Swansea Area Ratepayers' Association

Written on behalf of the Swansea Area Ratepayers Association and Group  
(SARA/SARG) March 6, 2024

## A New Plan Suggested for the 2461 Bloor West New Mid-Rise Conversion Build

Proposed Building

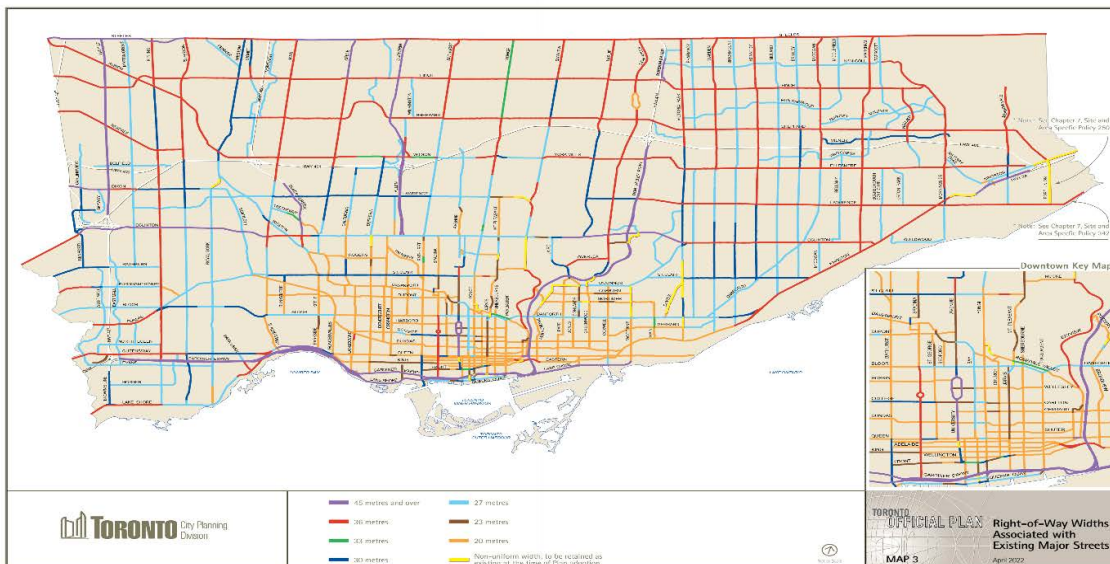
The maximum height of this mid-rise building should equal the width of the avenue. If greater than the 30 metres in height which relates to the 30m width of the avenue at the point of location for 2461 Bloor Street, it becomes a tall slab tower. On the architectural drawings, it rises to a height of 47m including the mechanical room and amenity space which is about 52% beyond the maximum height of 30m and could therefore be designed as point towers following the rules of Tall Buildings!!

The Developer has bulked up the 12<sup>th</sup> floor roof with outdoor amenity space while maintaining the required outdoor amenity (e.g. the dog care area) and potential green space on the 2<sup>nd</sup> floor outdoor deck. There is also the perception that this roof top amenity space would become residential units. As this space is counted as part of the FSI calculation, I questioned the existence of a 13<sup>th</sup> Floor with the Developer's Project Manager. She avoided the question by saying that this is what they liked to do on their buildings downtown!!

- a) As the City planner has confirmed that the **Developer is now asking for 13 storeys, this is a case of Incorrect Notice**, lack of Transparency and deceptive in everyone's communication with the Swansea Neighbourhood impacted by the excess.

3. **Replace** outdoor amenity space with **private exclusive use balconies** which are inset into each unit.
4. **Increase the 260m<sup>2</sup> (2,790 ft<sup>2</sup>) Retail component** to adequately **replace the employment lost by the conversion of 9 retail outlets into a single address of the new condominium corporation.**

2. **As this is a shallow lot of 31m depth, it is a must that the measurement of the angular plane be used to support appropriate step backs and setbacks both at the front and back of the building.** Separated only by a 6.059m wide public laneway, the adjacent neighbourhood trees, gardens and open spaces need to be protected against the proximity, shade, slab effect of the new building to the south and the Commercial, Restaurant and Patio businesses on the northside of the Bloor West Village. The Bloor West Village is entitled to 5 hours of shadow free, sunshine and daylight a day.
